POWER DISTRIBUTION LIMITS3/4.2.3 RCS FLOW RATE AND NUCLEAR ENTHALPY RISE HOT CHANNEL FACTORLIMITING CONDITION FOR OPERATION

ATTACHMENT 2

REACTOR COOLANT SYSTEM (RCS) FLOW RATE MEASUREMENT

ATTACHMENT 3

FIGURE 1

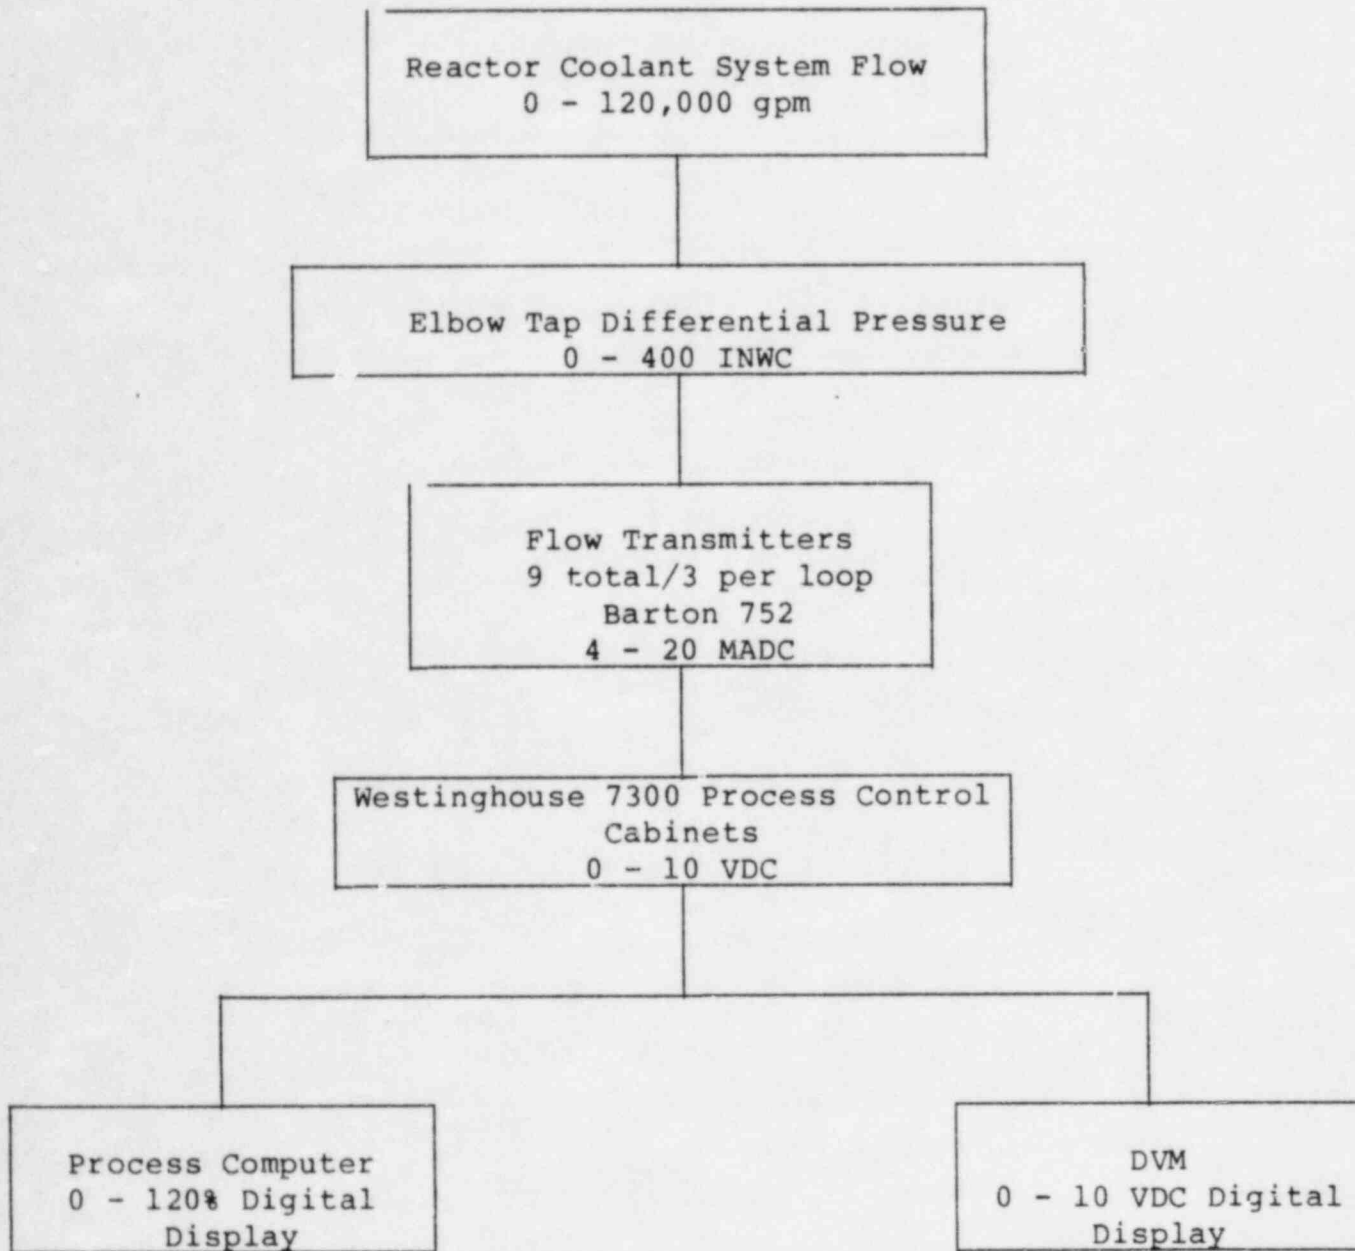
the elbow tap flow indication is depicted in Figure 1. Table 2 provides the list of components involved in the precision calorimetric flow calculations. The overall loop flow measurement uncertainty is the statistical summation of individual uncertainties (accounting for interactive effects where necessary) and appears at the bottom of Table 2
